Report: TAB

Function: Test, Adjust, & Balance

Date: 10/28/2024

**10-28-24 KROGER #024-721 - LEXINGTON,
KY (WIW)**

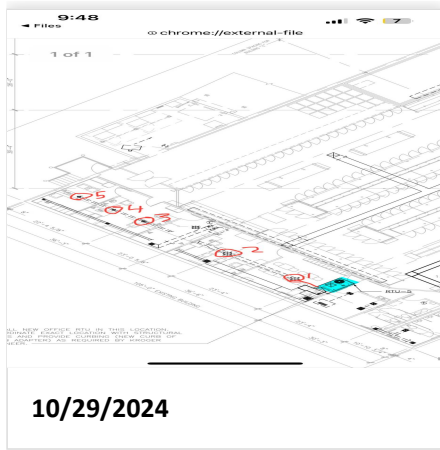
Issue Name : RTU-5 Economizer controller does not actuate OA/Return damper.
Description : RTU-5 Economizer controller does not actuate OA/Return damper. OA damper does fully close when fan is no longer running. Changing economizer controller setpoint does not open or close OA damper. OA is always in an approximately 10% open position.
